ASSESSMENT REPORT

45-47 Macquarie Street and 134-140 Marsden Street, Parramatta (MP 09_0167 MOD 5)

This report is an assessment of a request to modify the Project Approval (MP09-0167) for a mixed use development at 45-47 Macquarie Street & 134-140 Marsden Street, Parramatta.

Figure 2: Hunter Street (southern elevation) - Comparison between approved (left) and proposed (right)

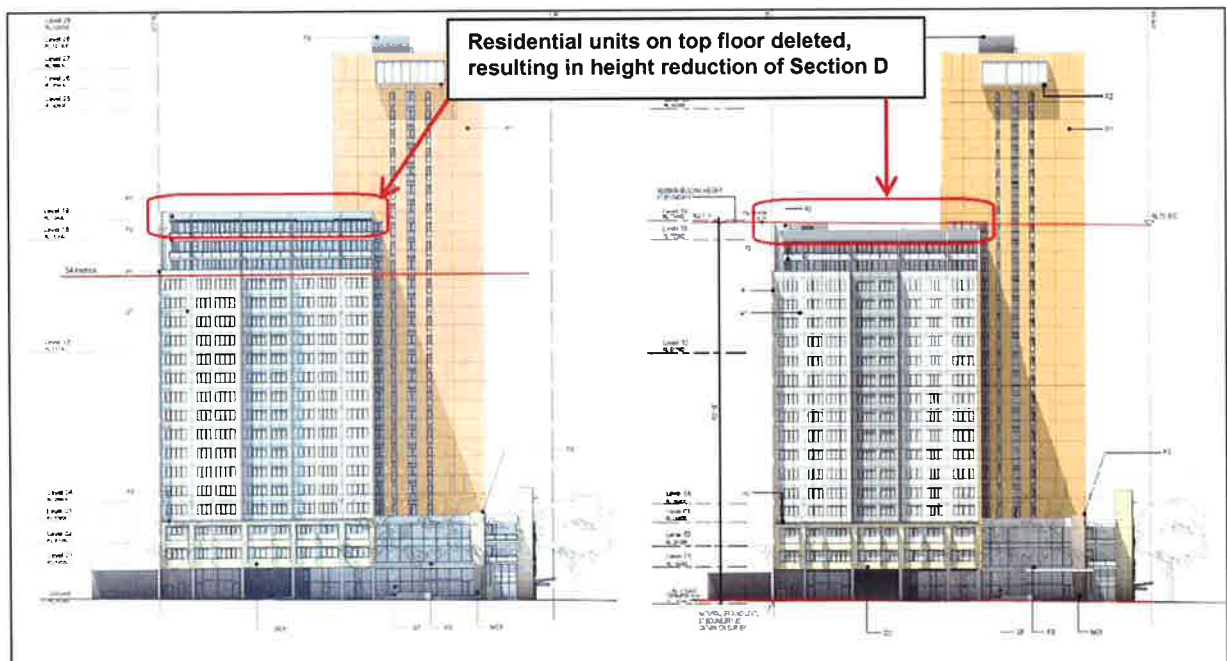
| Proposed Modifications | |
|-------------------------------|--|
| <i>Building Height</i> | <ul style="list-style-type: none"> • Reduce the height of the building in Section D (south-west wing) by 1.8 m, from 64 m to 62.1 m (see Figure 2). • Reducing the building height would result in the deletion of five - one bedroom apartments and one - two bedroom apartment at Level 18 in Section D; • Level 18 is now proposed to be converted to a rooftop terrace in lieu of the apartments. • The proposal would also result in the following minor changes to the south-western corner of the building in Section C: <ul style="list-style-type: none"> - the plant and circulation space would be converted to a studio apartment at Level 19; and - the one-bedroom plus study would be reconfigured to a two bedroom apartment at Level 18. • The proposal would result in a net reduction of five apartments, reducing the total number of apartments from 591 to 586. |

| Issue | Consideration | Recommendation |
|------------------------|---|---|
| <i>Building Height</i> | <ul style="list-style-type: none">The proposal seeks to reduce the height of 'Section D' of the approved building from approximately 64 m to 62.1 m. This would also result in the deletion of five apartments.The previously approved modification (MOD 4) resulted in significant increases to the approved building height and it was deemed to be a 'controlled action', requiring separate assessment and approval under the EPBC Act, 1999, due to its potential impacts on the world heritage listed Old Government House.On 22 January 2016, the Commonwealth Department of Environment approved the proposal subject to a condition limiting the height of Section D of the building to 62.1 m.The proposed modification would ensure the approved development is consistent with the separate approval issued by the Commonwealth Department of Environment.There would be no change to Sections A, B or C of the | No additional conditions or amendments necessary. |

| Issue | Consideration | Recommendation |
|--|--|--|
| | <p>approved development.</p> <ul style="list-style-type: none"> The Department supports the proposed modification as it would not result in any additional impacts and would be consistent with the approval issued by the Commonwealth Department of Environment. | |

Figure 3: Proposed new building identification signage - Comparison between approved signage zone (left) and proposed sign (right)

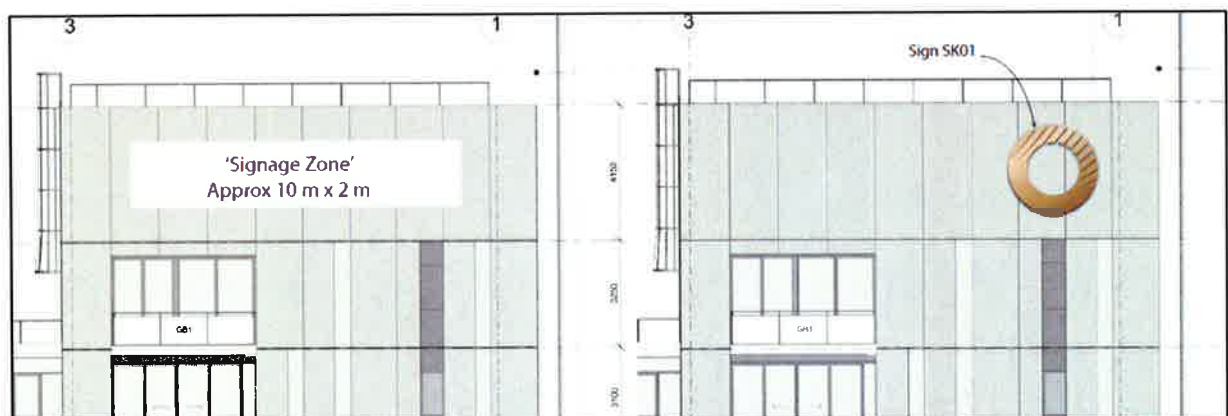
| Proposed Modifications | |
|-------------------------------|--|
| <i>Signage</i> | Replacement of a 10m x 2m signage zone with a sign showing the Crown Group logo (refer figure 3). |

| <i>Issue</i> | <i>Consideration</i> | <i>Recommendation</i> |
|------------------------|--|---|
| <i>Signage</i> | <ul style="list-style-type: none"> • Condition B42 requires two retail signage zones to be replaced by a single signage zone. • The proposal incorporates amended plans illustrating a single signage zone. The Department is therefore satisfied the amended plans achieve the requirements of Condition B42. • The proposal also seeks to incorporate a building identification sign showing the Crown Group logo. • The sign is located within an approved signage zone (refer to Figure 3) and the Department is satisfied it is consistent with the requirements of SEPP 64, as it is compatible with the design and character of the building, does not result in visual clutter and relates to the corporate use of the building. | The updated plans are recommended for inclusion in to the instrument of approval and Condition B42 is recommended for deletion. |
